Title - Sujet Palace Grand Theatre Foundation Rep	
Solicitation No. - N° de l'invitation EZ899-152418/A	Amendment No. - N° modif. 004
Client Reference No. - N° de référence du client	Date 2015-06-29
GETS Reference No. - N° de référence de SEAG PW-\$PWY-022-7522	
File No. - N° de dossier PWY-5-38030 (022)	CCC No./N° CCC - FMS No./N° VME
Solicitation Closes - L'invitation prend fin at - à 02:00 PM on - le 2015-07-08	Time Zone Fuseau horaire Pacific Daylight Saving Time PDT
F.O.B. - F.A.B. Plant-Usine: <input type="checkbox"/> Destination: <input checked="" type="checkbox"/> Other-Autre: <input type="checkbox"/>	
Address Enquiries to: - Adresser toutes questions à: Arthur (PWY), Carolyn	Buyer Id - Id de l'acheteur pwy022
Telephone No. - N° de téléphone (604) 775-6667 ()	FAX No. - N° de FAX (604) 775-6633
Destination - of Goods, Services, and Construction: Destination - des biens, services et construction: Parks Canada - Palace Grand Theatre - Dawson City, YT

Amendment 004 has been raised to incorporate Addendum No. 2.

PROJECT NO. R.068835.001
PALACE GRAND THEATRE FOUNDATION REPLACEMENT
DAWSON CITY, YUKON TERRITORY

ADDENDUM No. 2
Jun 26, 2015

SK-MOL
144902132

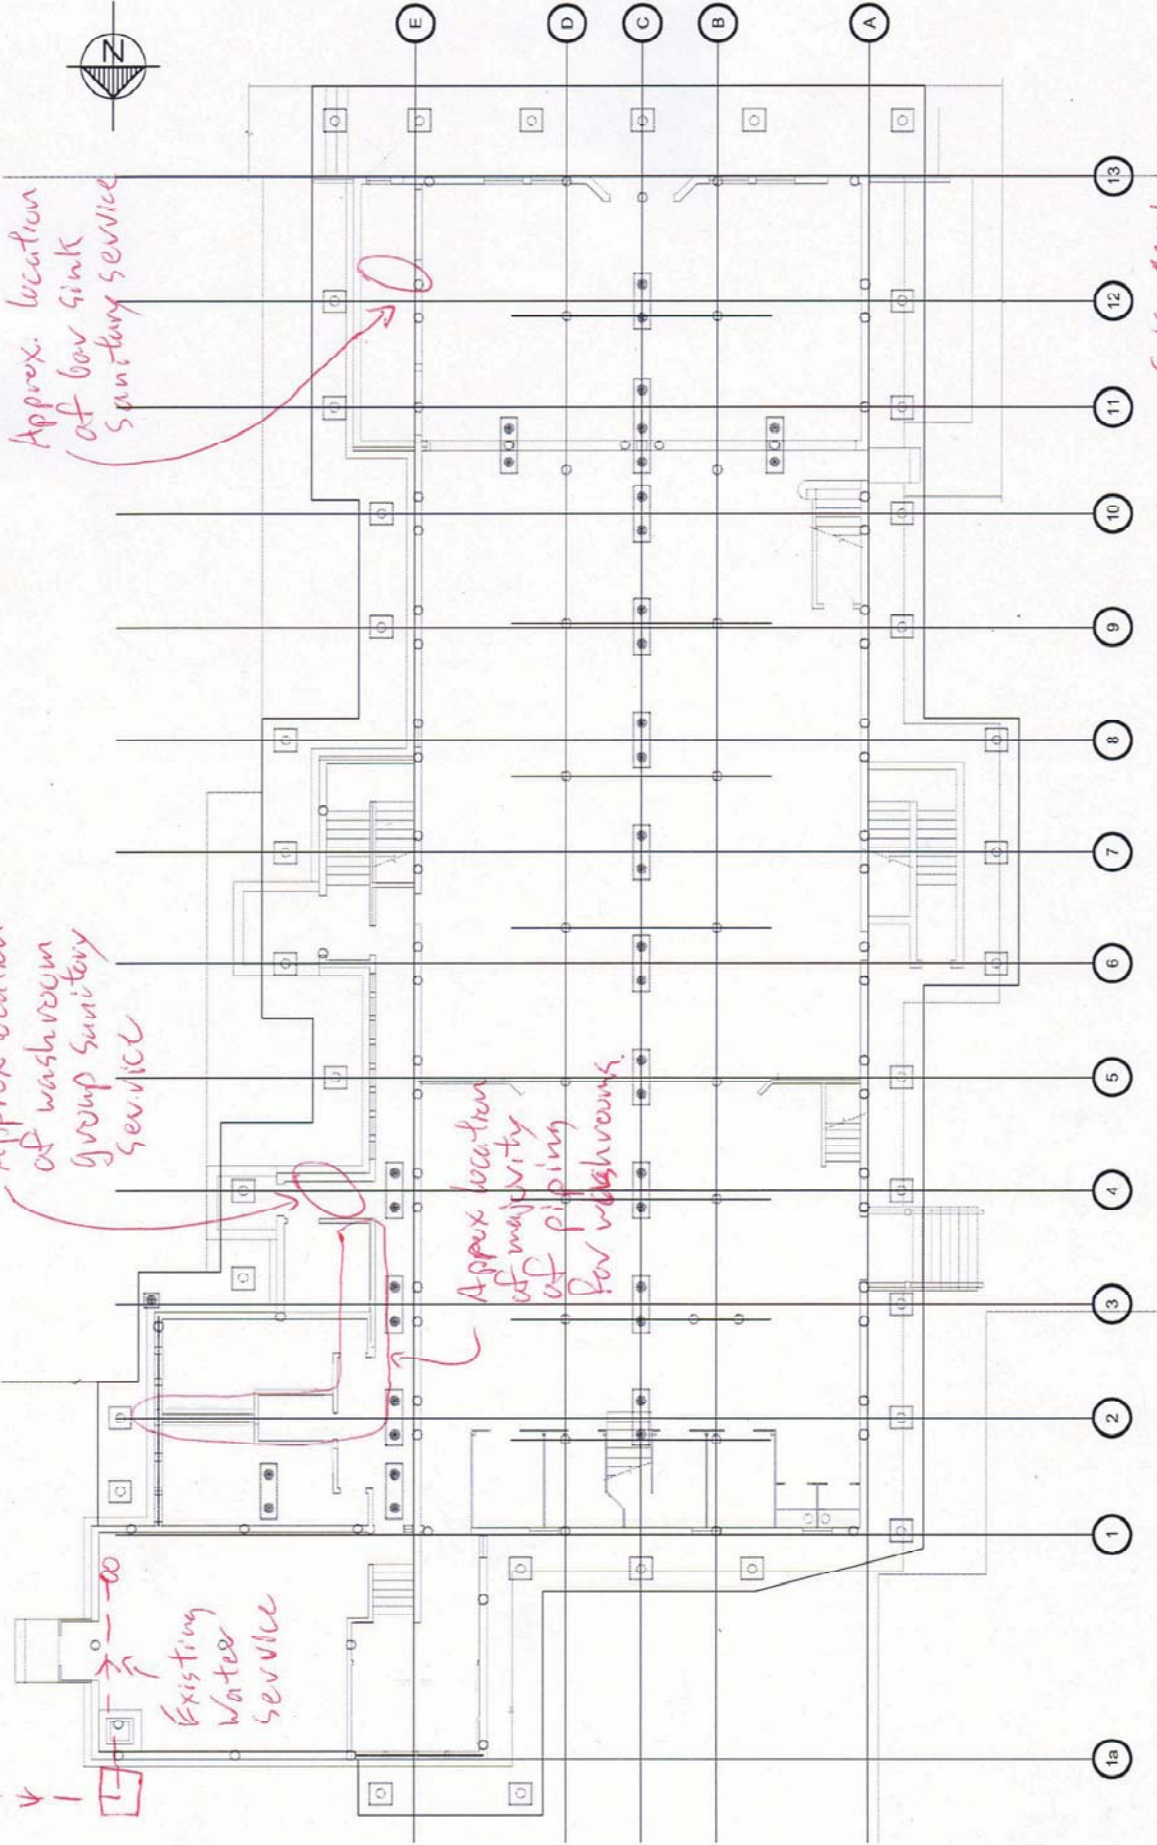
Request for Information Response
RFI-M01 (Mechanical)

ITEM #	DESCRIPTION	RESPONSE
M029.1	<p>Per emailed questions from bidders, dated June 18, 2105:</p> <p>2. Please provide details on existing sanitary and water services- size, locations, material etc. Provide clarification on disconnection and reconnection of both sanitary and water lines. Will plumbing in existing bathrooms need to be redone?</p> <p>3. General scope (01 11 55 item 1.2) has remove and re-install existing mechanical and electrical. Drawings show to remove and dispose of existing HVAC. Please clarify what re-installation is required.</p> <p>4. Please clarify scope of sprinkler re-installation.</p>	<p>Responses are as follows</p> <p>2. Refer to attached sketch SK-M01 for sanitary and water services locations. Sanitary services are ABS-DWW and water service is steel. It is expected sanitary services under washrooms will require minimal if any modification to accommodate foundation replacement.</p> <p>3. No mechanical re-installation required. Work to be completed under Tender 3.</p> <p>4. Sprinkler re-installation not required.</p>

Approx. location
of bar sink
sanitary service

Approx location
of washroom
group sanitary
service

Approx location
of majority
of piping
for washrooms.

Existing
Water
service
